**Land off Scamps Hill,
Lindfield**

Designers Response Report

Report Reference 1723/4/A

Road Safety Audit: Stage 1

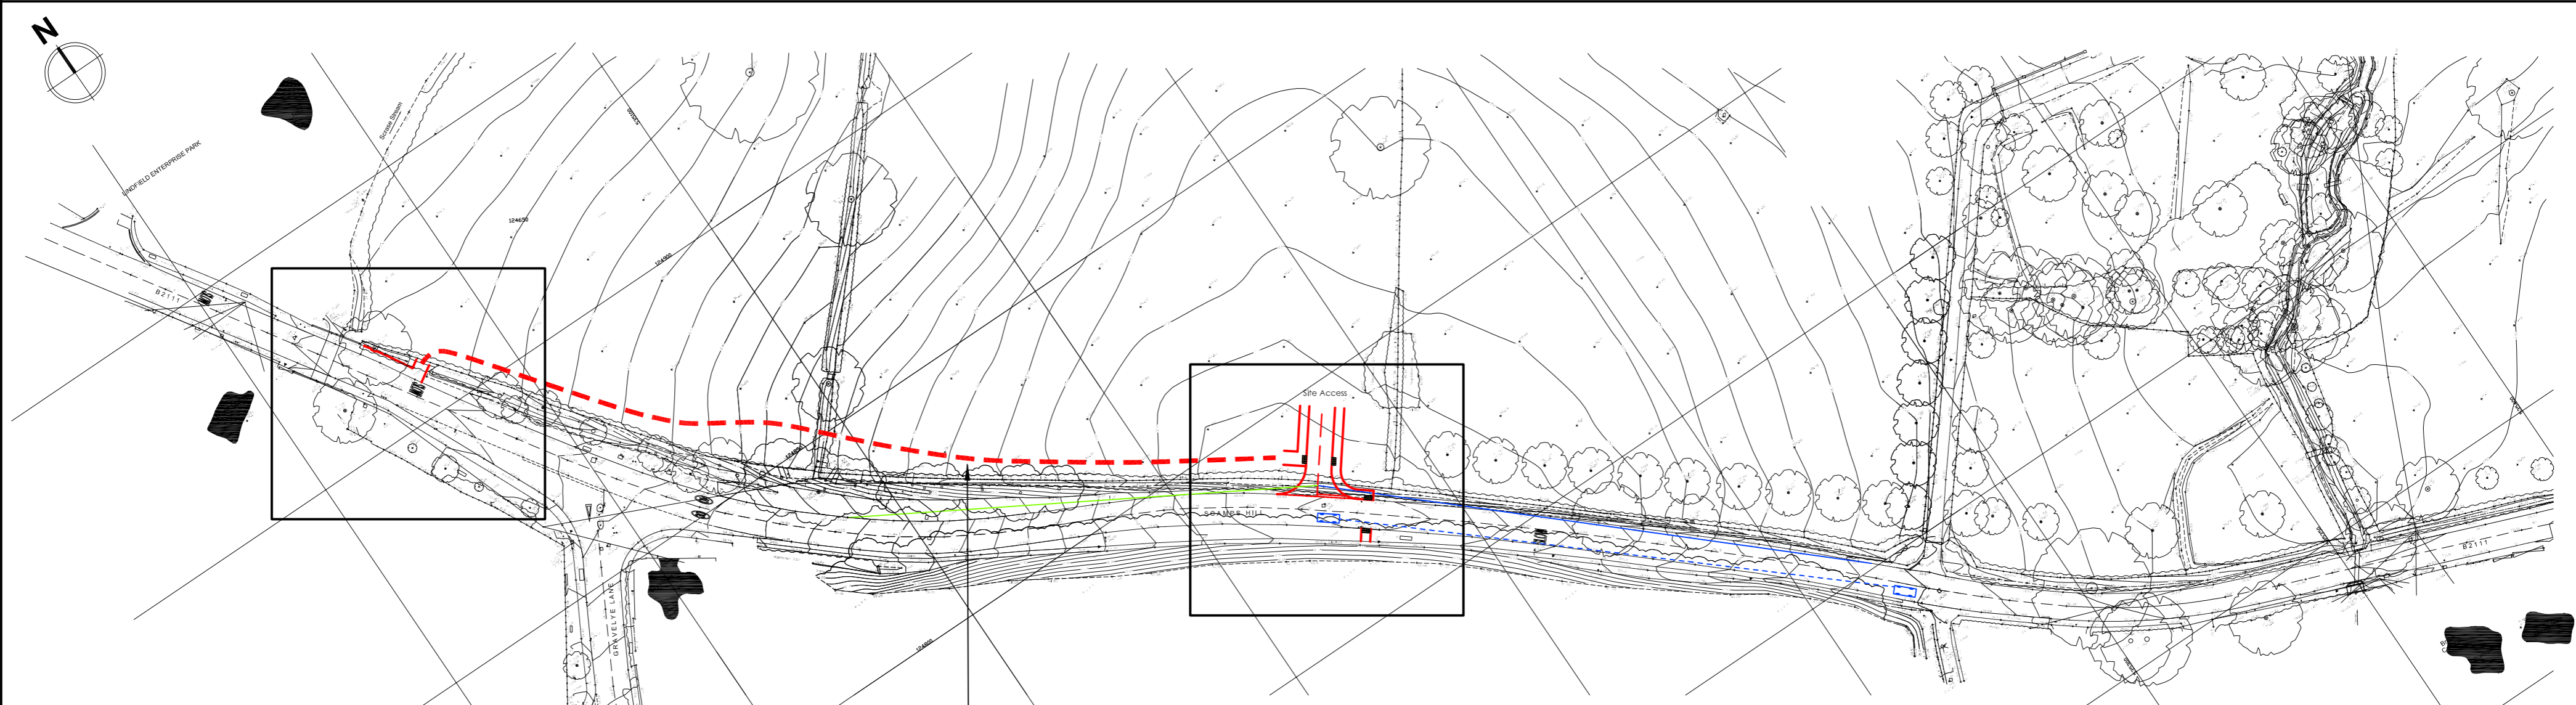
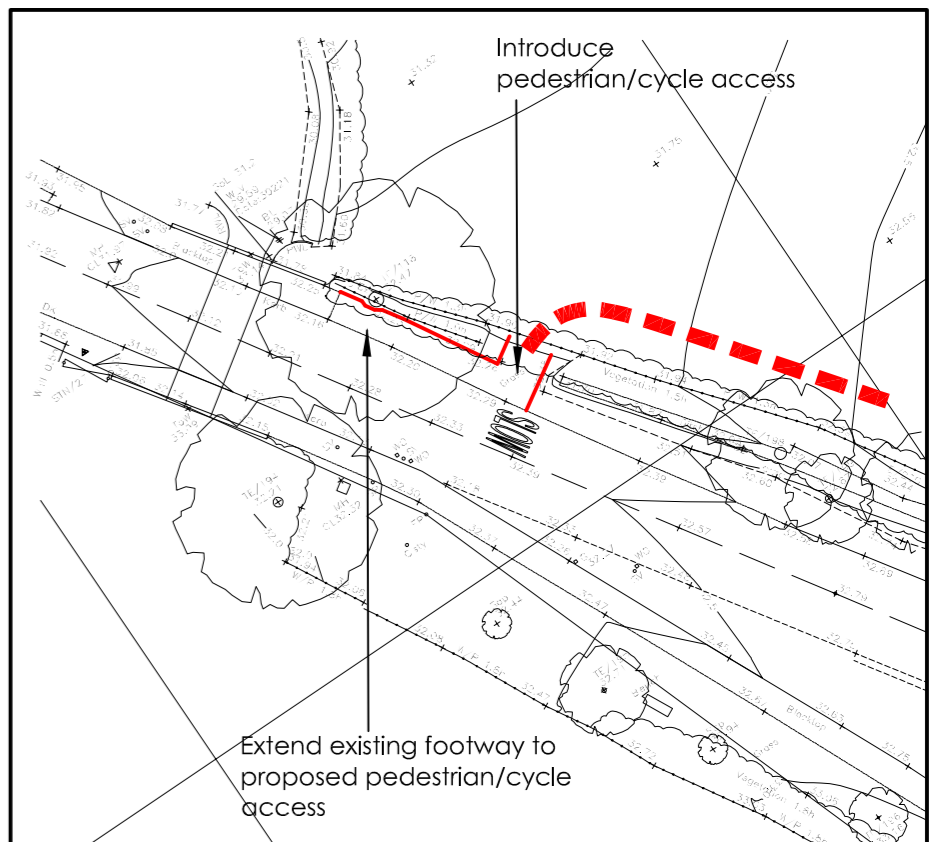
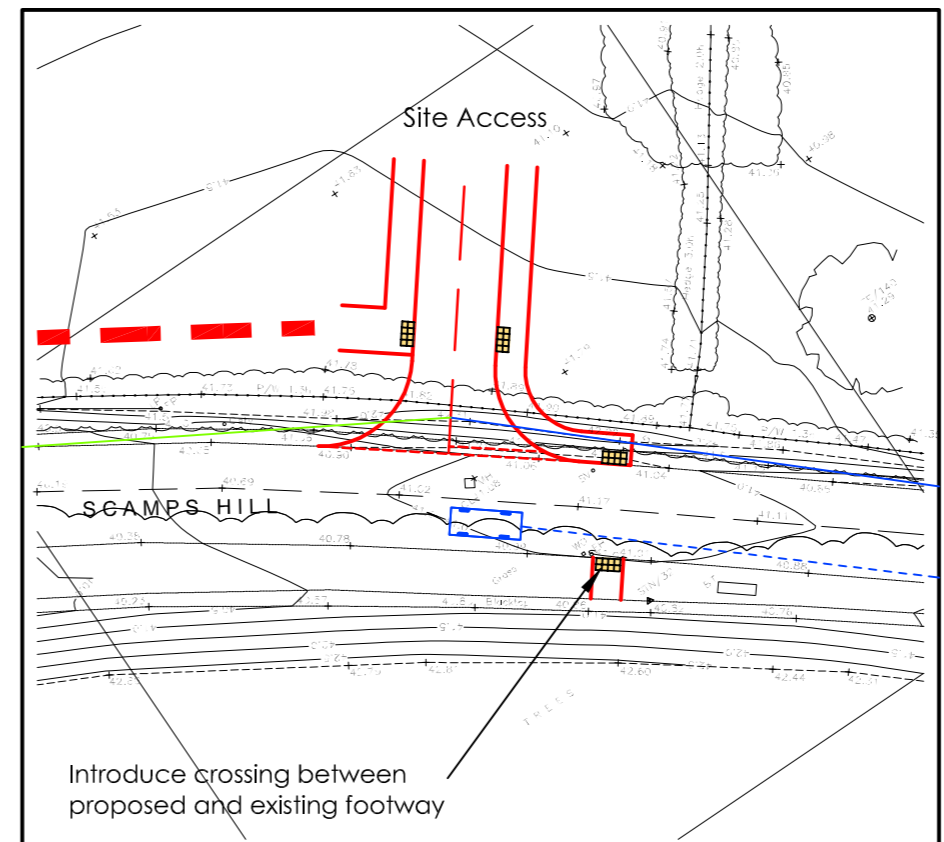
2.1 **PROBLEM 1-1**

2.1.2 Summary: Obstructed visibility will increase the risk of failure to give way and pedestrian/vehicle collisions.

2.1.3 Examination of the drawing provided does not clearly show any site clearance. The verge is heavily overgrown (photos). Based on the drawings the existing vegetation will obstruct visibility and as such will increase the risk of failure to give way and pedestrian/vehicle collisions.

2.1.4.1 Ensure that all vegetation is removed that can obstruct visibility.

2.1.5.1 It is accepted that some hedgerow will need to be removed/relocated near to the Site access to enable the provision of protected visibility splays. However, Drg No 1723/08 demonstrates that the majority of the sightlines are contained to within the grass verge (splay to the right) or the Scamps Hill carriageway (splay to the left) and are unaffected by vegetation.

Project	SCAMPS HILL, LINDFIELD	Title	PROPOSED ACCESS ARRANGEMENTS	Drg No	1723/08	Rev	A		Telephone 0161 972 0552 Email aha@ashleyhelme.co.uk Website www.ashleyhelme.co.uk Address 76 Washway Road, Sale, Manchester, M33 7RE
Client	GLADMAN DEVELOPMENTS LTD	Date	FEBRUARY 2024	Scale	1:1000@A2

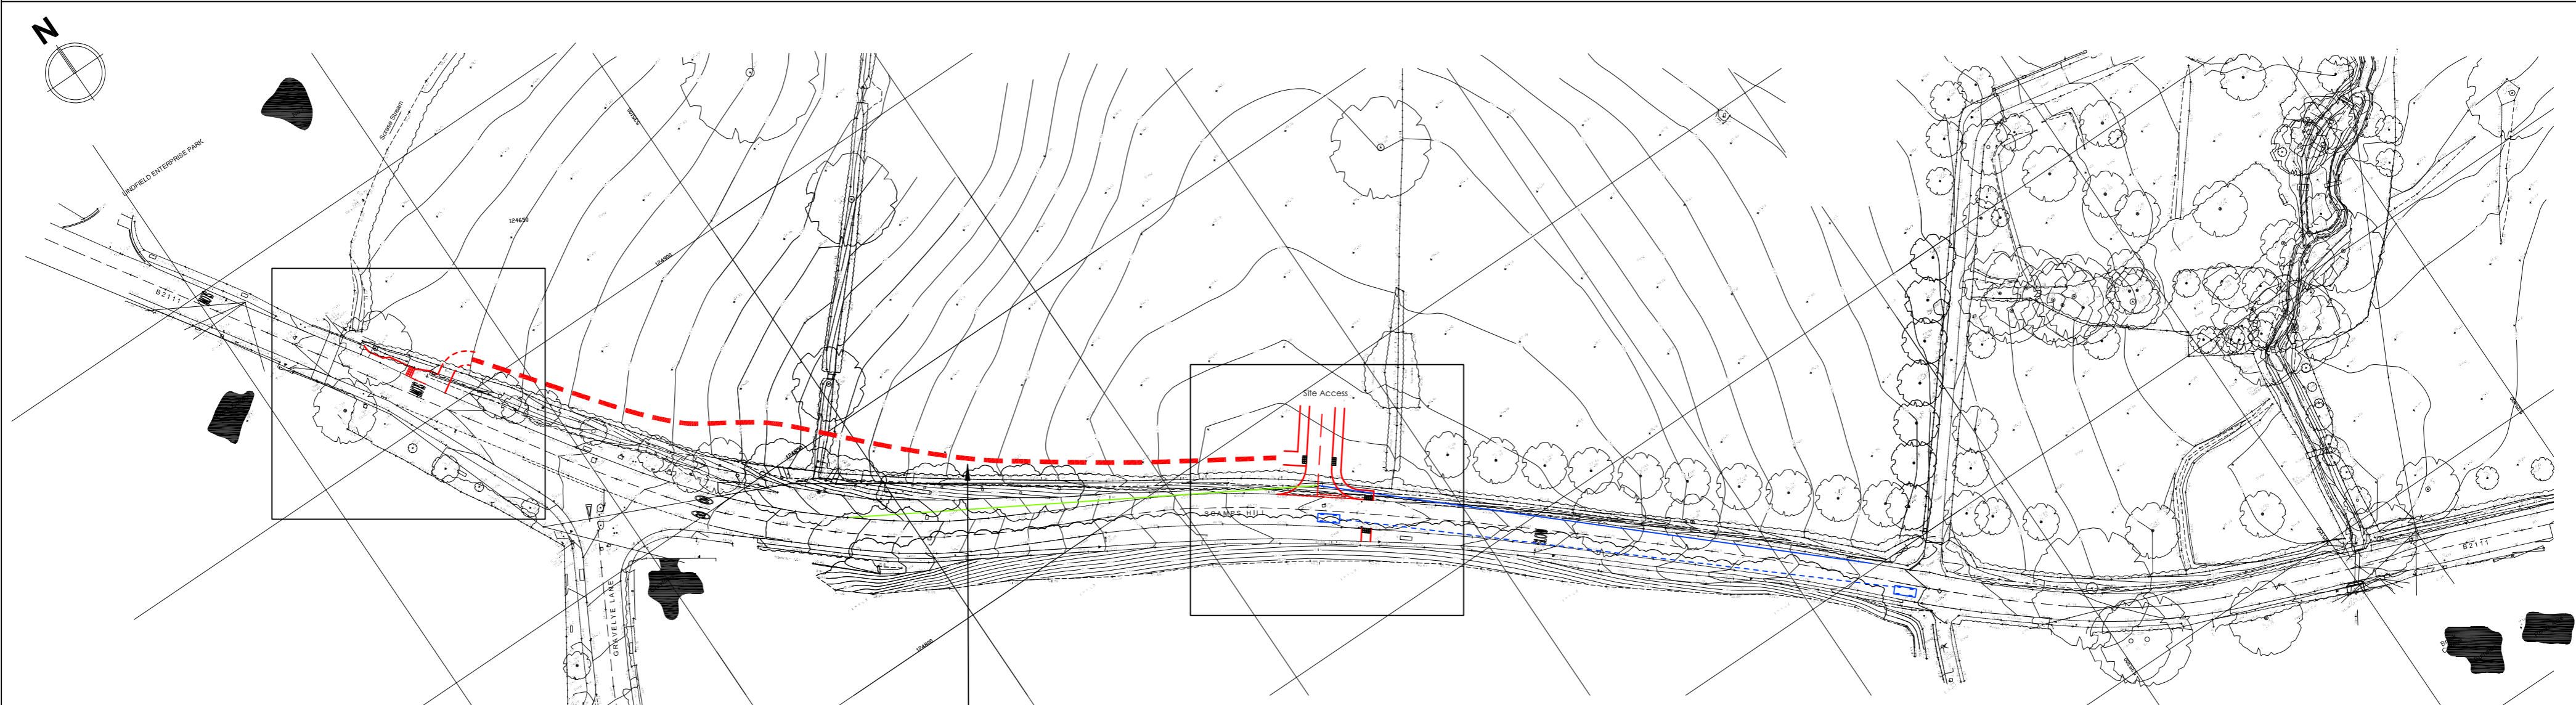
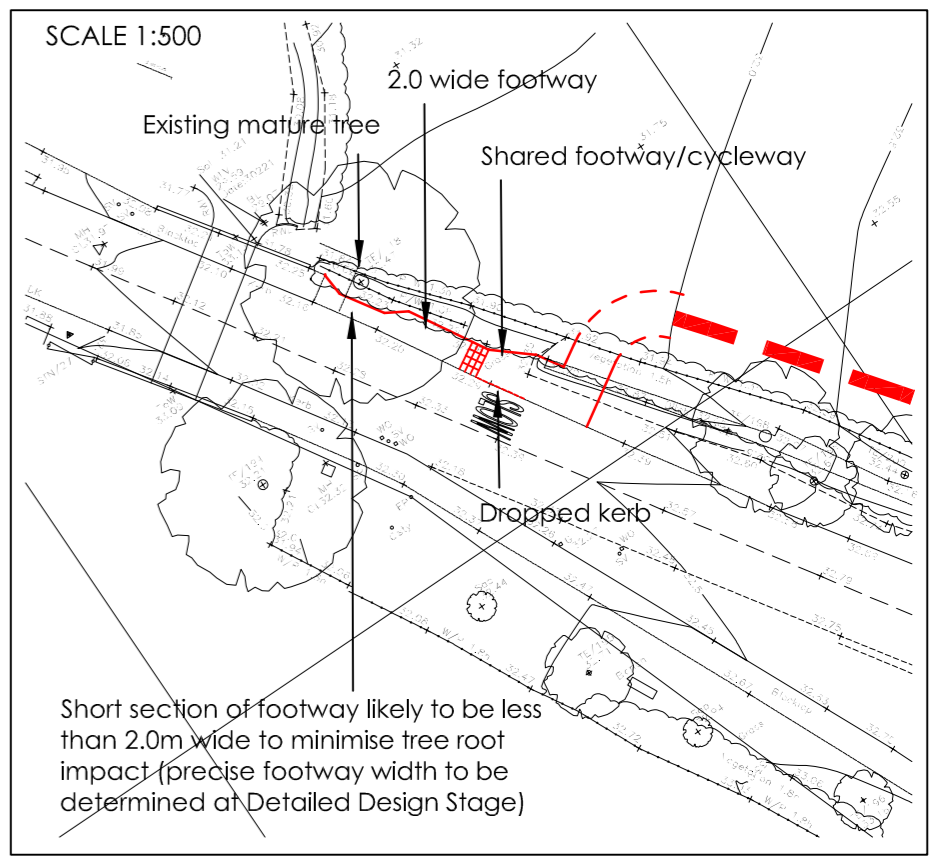
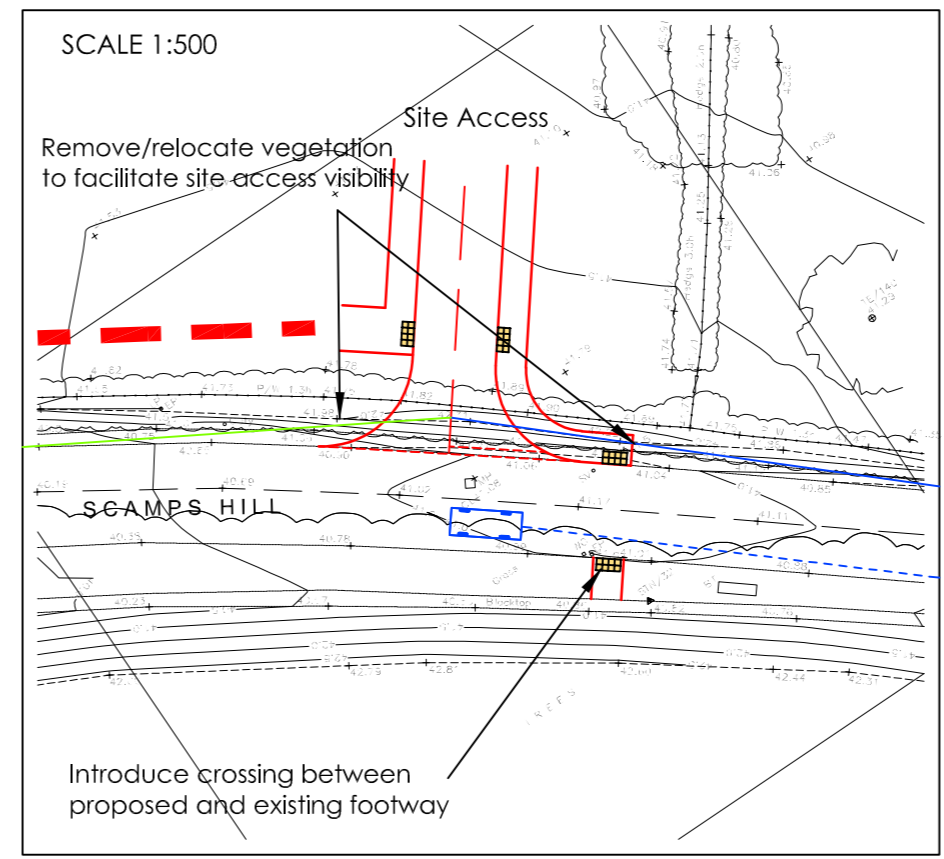
2.2 **PROBLEM 1-2**

2.2.2 Summary: A lack of safe cycle facilities will increase the risk of cycle/pedestrian collisions and cyclist injuries.

2.2.3 It is proposed to create a 3.0m shared use route through the site and connect up to an existing footway to the west of the site access near Gravelye Lane. There does not appear to be any means by which cyclists are directed to rejoin the carriageway. The Audit Team were also concerned that this would result in cyclists travelling westbound on the footway and onto the bridge over the Scrase Stream. The bridge parapet did not seem high enough to safely allow a cyclist to use the footway and ride over the bridge (photos). With the footway being narrow it would seem likely that there could either be a collision between a cyclist and a pedestrian or even due to the narrow width a cyclist could topple over the parapet.

2.2.4.1 Either ensure that cyclists can safely rejoin the carriageway or increase the height of the parapet to 1400mm.

2.2.5.1 It is not the intention to encourage cyclists to use the existing footway on the north side of the B2111 and, particularly, the section of footway on the bridge. The scheme will include suitable cycle transition treatment with associated dropped kerbs, tactile paving and signage. An indicative arrangement is shown on **Drg No 1723/08/A** (refer Appendix C). The arrangement can be further considered at Detailed Design stage.
